**CERTIFICATE OF APPROPRIATENESS**

**Property:** 1117 Peddie St. – 5,000 SF partially vacant lot – Lot 16, Block 108, North Norhill

**Proposal:** New Construction

*Figure 2 - Current Proposed South/Front Elevation*

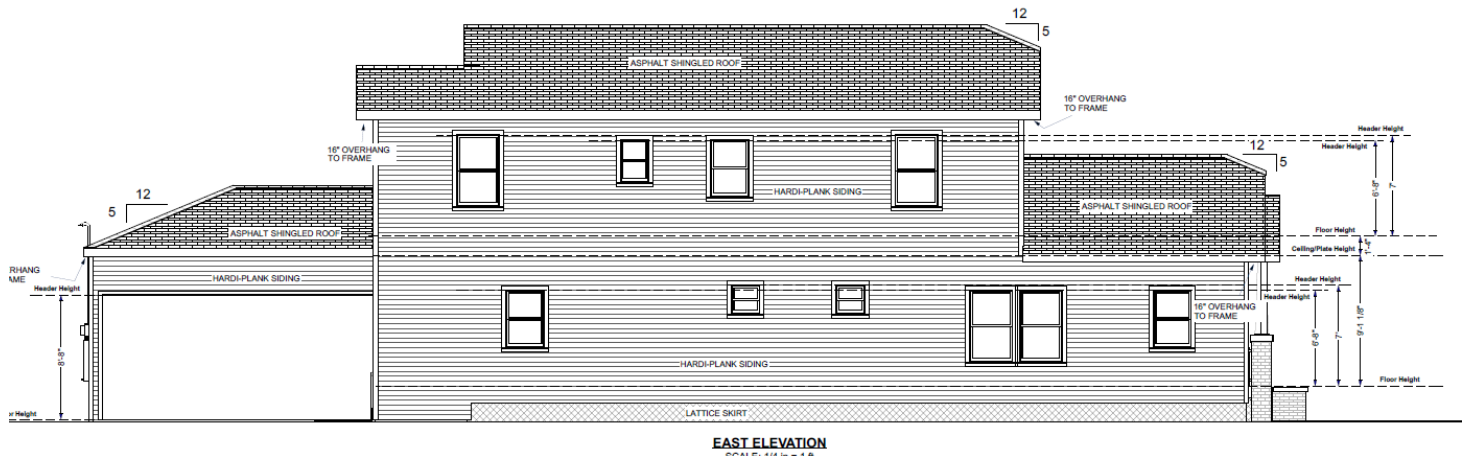
**Recommendation:** Approval with conditions: 1) a portion of front wall moved inward 1' to 1.5' and roof of portion to rear to be a hip, like the proposed 1<sup>st</sup> floor; 2) 2<sup>nd</sup> story wall on east elevation moved inward a minimum of 1', 3) 2<sup>nd</sup> story front fenestration to be approved by staff.

The second floor is too far forward. The second floor is only 15'- 8" behind the front wall of the house. A second floor must be subordinate to a one-story volume. For remodeling projects, a second floor should be set back at least half the distance between the front wall of the existing structure and the furthest point of the rear of the existing structure. This is a complete new house but the placement of the second floor does follow the spirit of this requirement. In an informal measurement of second floor additions in Norhill most were at least 25' back from the front face of the house.
